### **Submission re**

#### **PLAN CHANGE 23 – RURAL AND NATURAL ENVIRONMENT SUBMISSION ON PROPOSED PLAN CHANGE 23 TO THE MACKENZIE DISTRICT PLAN**

### **Additions to ONF 3 'Raincliff'**

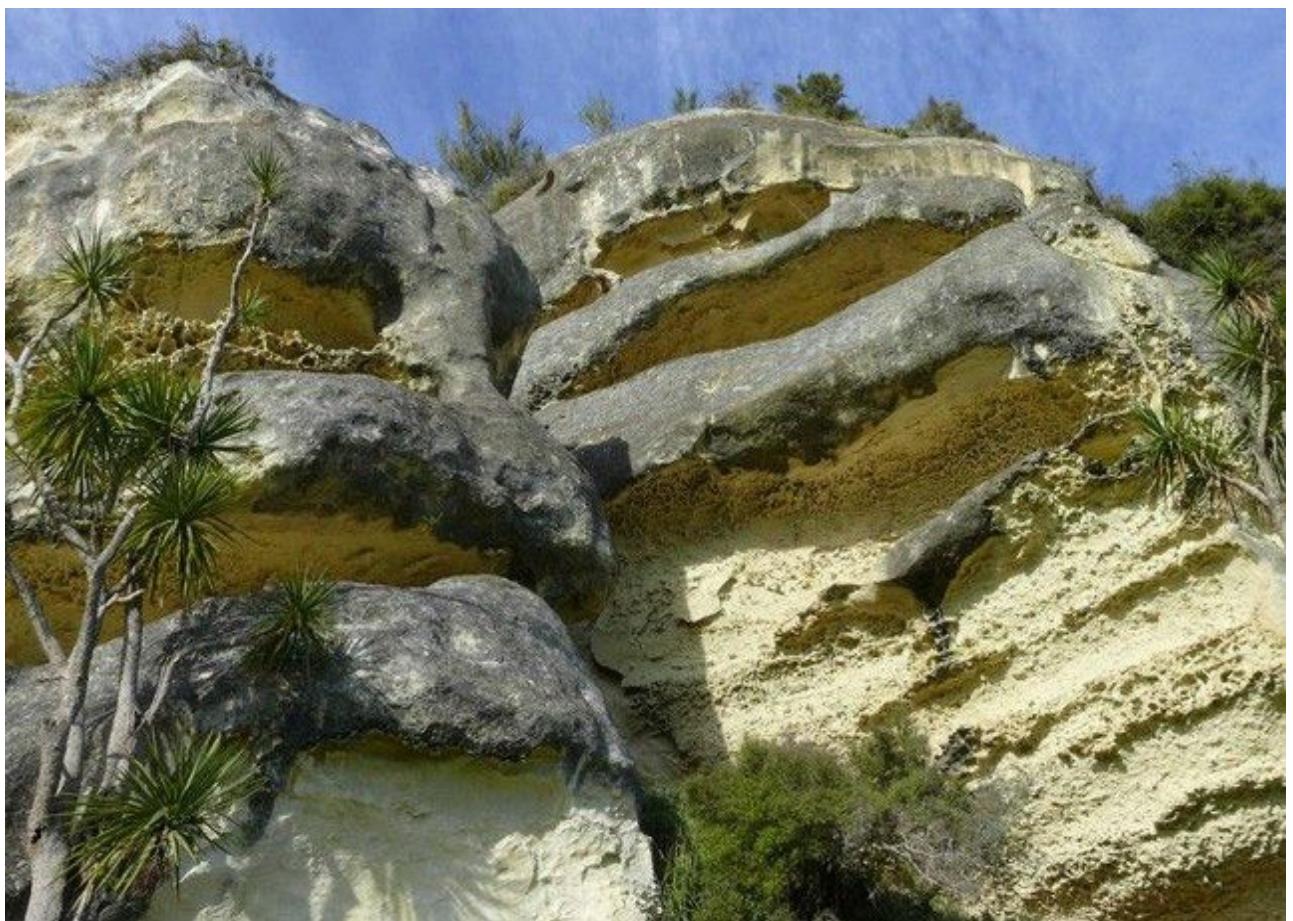
Generally I support the conditions and extent of the ONF 3 and mostly agree with the description. However, there need to be some additions as there are some other outstanding limestone formations in that area.

The first one is on the opposite side of the marked-out ONF i.e. facing north and north-east. These are notable limestone cliffs starting about 400m east of Gudex Road and leading towards the Opuha River and parts of them stretching along the river. The cliffs or parts are visible from a number of viewpoints on Gudex Road and from the north of the river. I attach some photos further down. The northwest part does also have rock art drawings.

The second possible addition is the limestone outcrop where the Raincliff homestead is built on. This outcrop is a very discernible from Middle Valley Road. Smaller outcrops lead right round to Spur Road. The homestead itself could be excluded. The proposal for this addition would need some checking on site and refining.

A map with suggestions for these additions is provided here. The part along the Opuha River might be joined at the south end with the described ONF 3.

### **Additions to ONL 2 ‘Two Thumbs Range’**

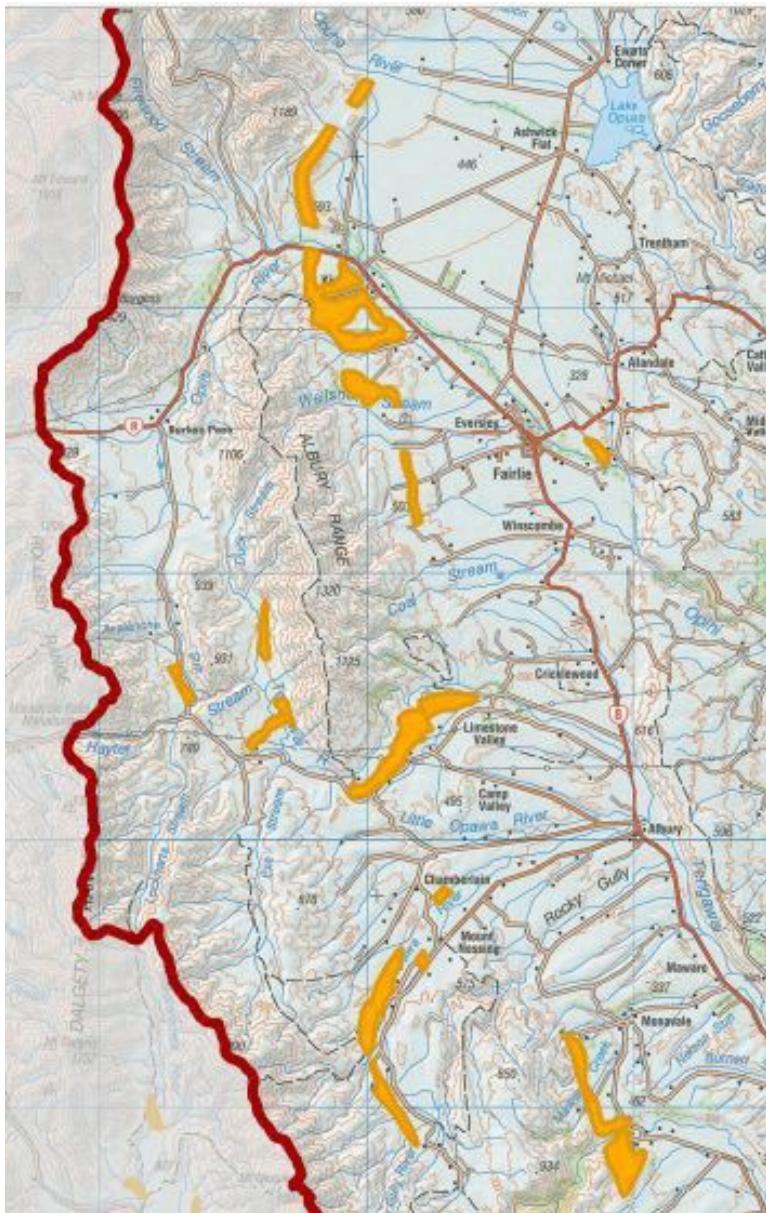
Generally I support the conditions and extent of the ONL 2 Two Thumbs Range and mostly agree with the description. However, there needs to be some addition in the area north-east of Kimbell to include some outstanding landscape features in the foothills including noteworthy limestone formations in that area.

These foothills contain some dramatic features like steep incised gullies and dominant ridges, partly with remnants of native vegetation. They are highly visible from the main road and form a substantial part of this landscape. In addition to this, the hill west of the Stoneleigh Road in parts contains limestone formations. While these are not much discernible from the distance, limestone formations are recognised as distinct and threatened landforms and ecosystems in New Zealand. These landforms, which are considered to be historically rare terrestrial ecosystems, exhibit high biotic diversity, providing habitats for plants and animals, some of which only occur on calciferous soils. Therefore, these important ecosystems are classified as Vulnerable and the indigenous vegetation that occurs here is acutely threatened. I have not been able to access these limestone parts, but it is highly likely that they provide habitat for threatened species due to the remoteness, the limited modification of the environment and the location and direction of limestone areas.

A map with a proposal for these extensions is attached. Exact boundaries need to be better refined. I also include a map of exposed limestone areas in the Mackenzie District which also shows the limestone areas west of Stoneleigh Road.

### **Addition to SNL 2 'Albury Range'**

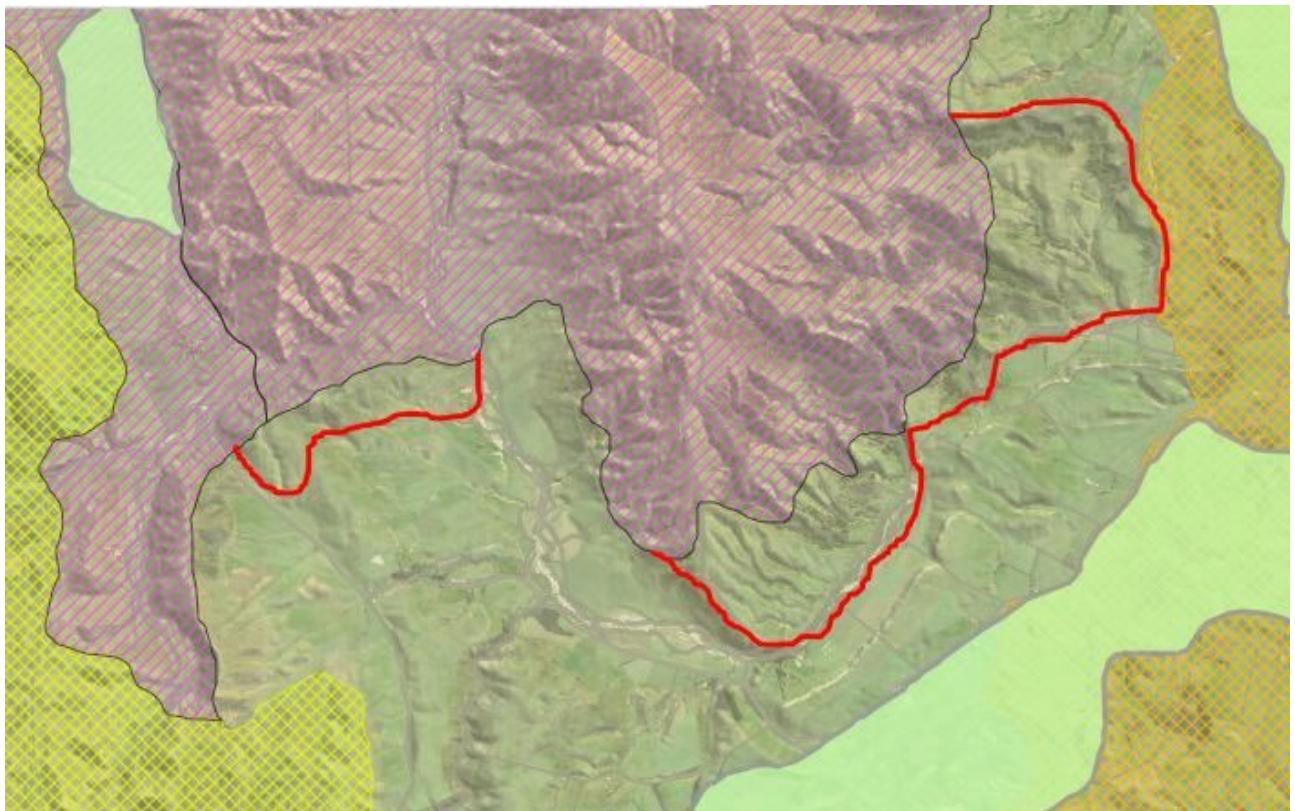
Generally I support the conditions and extent of the SNL 2 Albury Range and mostly agree with the description. However, there needs to be some addition along the south-east boundary near the Tengawai River. The Tengawai River is an integral part of this landscape section, especially the short, but notable Tengawai Gorge. The Gorge is already included., but generally the boundary should be on the south bank of the river.

The gullies on the west side of the Gorge lead down to the river and most have remnants of native vegetation. The boundary on the west could be slightly tweaked in order to accommodate for current farm tracks.

An extension towards the east below the Gorge is also recommended to include the lower reaches of the Tramway Stream/gully with regeneration of native vegetation. The musterer's hut on the north bank of the river could be excluded.

Another small extension is recommended between the Tengawai River and the Warratah Saddle. The south-facing hillside is quite visible from the Waratah Road and therefore it would make sense to include this side of the hill in the SNL. The noteworthy limestone formations on Duck Stream are already included in the SNL.

A map with a proposal for these extensions is attached. Boundaries need to better defined. Near the Tengawai Gorge this SNL and the proposed ONF 'Tengawai Cliffs' could share a boundary for a short stretch.

### Proposed Outstanding Natural Feature 'Tengawai Cliffs'

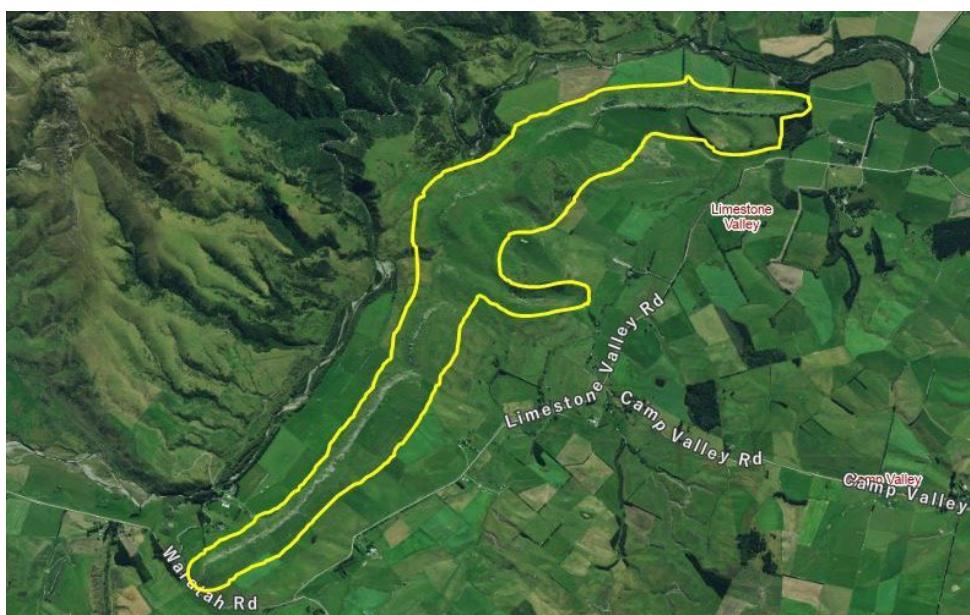
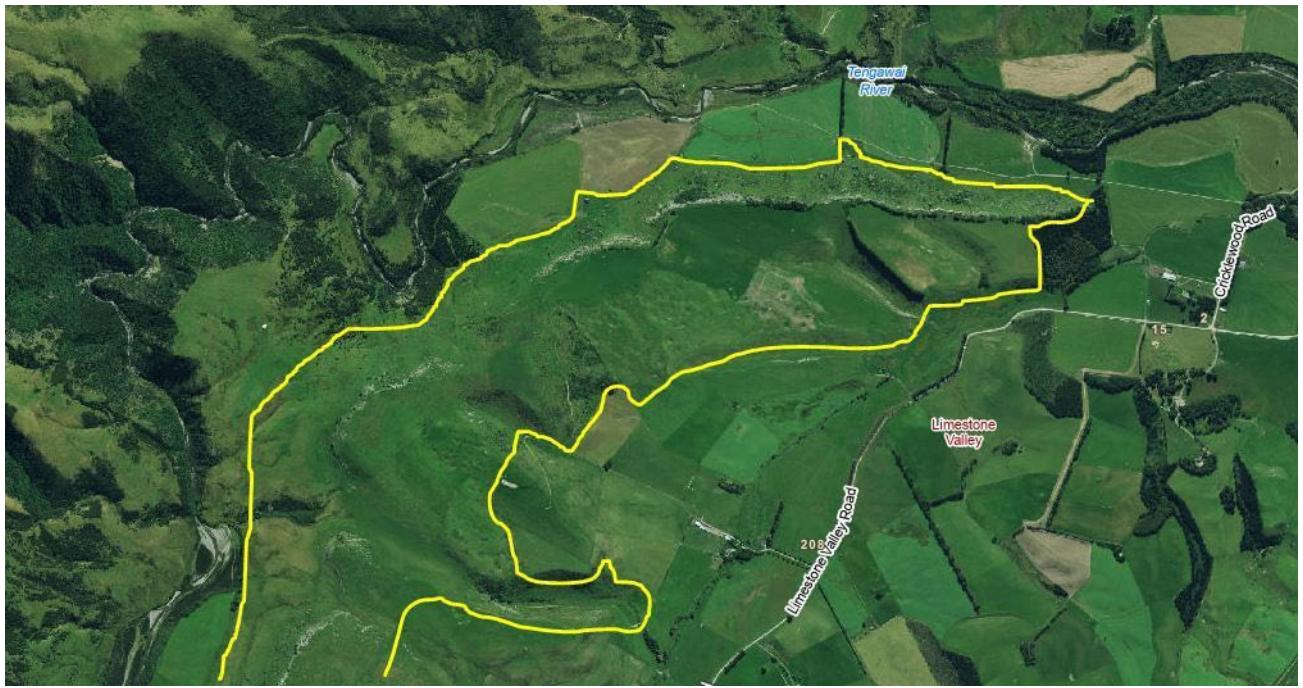
An important natural feature in the Eastern Mackenzie District has been overlooked in the Landscape Study. This is the area of the Tengawai Cliffs, an outstanding limestone scarp from a landscape aspect, though it is not so visible from public accessible places. This is by far the most significant and prominent limestone area in the District. Limestone formations are recognised as distinct landforms and ecosystems in New Zealand (Williams et al. 2007; Rogers et al. 2018). These landforms, which are considered to be historically rare terrestrial ecosystems, exhibit high biotic diversity, providing habitats for plants, birds, bats, lizards, invertebrates and micro-snails (Worthy 1997; Frank 2018). However, these important ecosystems are classified as Vulnerable (Holdaway et al. 2012; Wiser et al. 2013) and the indigenous vegetation that occurs here is acutely threatened (Walker et al. 2006; Cieraad et al. 2015)

The area has also some important geological features like an area with numerous sinkholes in the north-east part and a number of rock art sites (as shown in Figure 10 of the Landscape Study). My limestone book (Frank H. 2018. South Canterbury Limestone - Landscape of Dreams - Nature's Treasure Chest. Timaru) has some details and a number of photos. In fact, both the title and the back page show features from there. I attach some photos, but I am happy to send more photos, if this would be helpful.

Therefore I propose a new ONF. Here I attach maps for a proposal of an Outstanding Natural Feature 'Tengawai Cliffs'. The boundary is pretty obvious on the north and northwest side near the Tengawai River. It could be tweaked a bit on the north-east section. One map is more of an overview, the other two show the north part and south part and these need to be joined.
